## Product Change Notice (PCN)

Your customer number:  
Your contact person:  
Tel.: +49 8153 9999 699  
E-mail: [PDN@raylase.de](mailto:PDN@raylase.de)  
Date of publication: 28/03/2025  
PCN ID/version: 202502-01

Due to application-specific requirements from the electromobility market, water-bearing, nickel-plated brass plug-in connections (fittings) for water cooling must be avoided. We are therefore converting all water connections for the product lines and components listed below to stainless steel. This will not change or impair the previous functionality.

### Graphic overview:

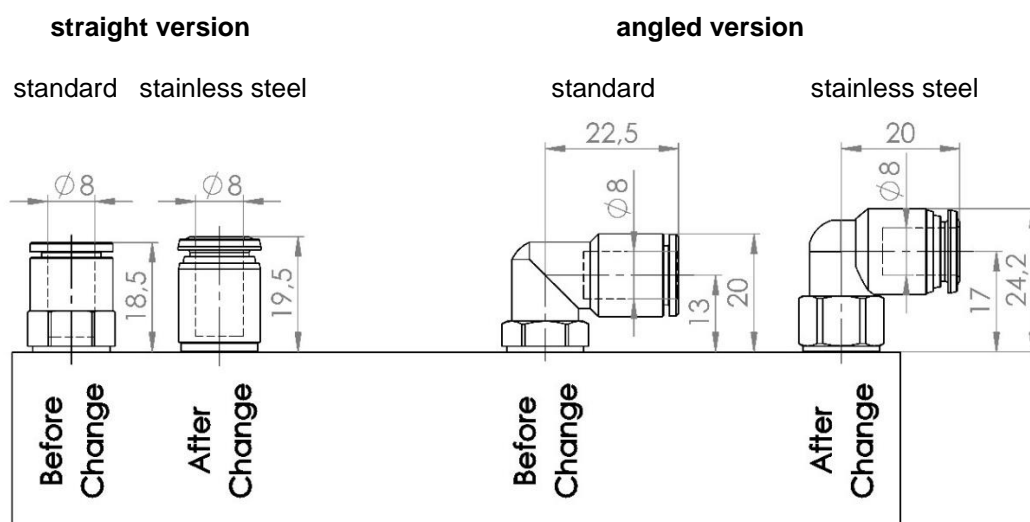
The dimensions of the new stainless steel water plug-in connections differ only slightly from the previous nickel-plated brass plug-in connections (→ see graphic overview).

Due to their position on the master block of the deflection units and on the collimators, it cannot be assumed that this will cause collisions in existing machine generations.
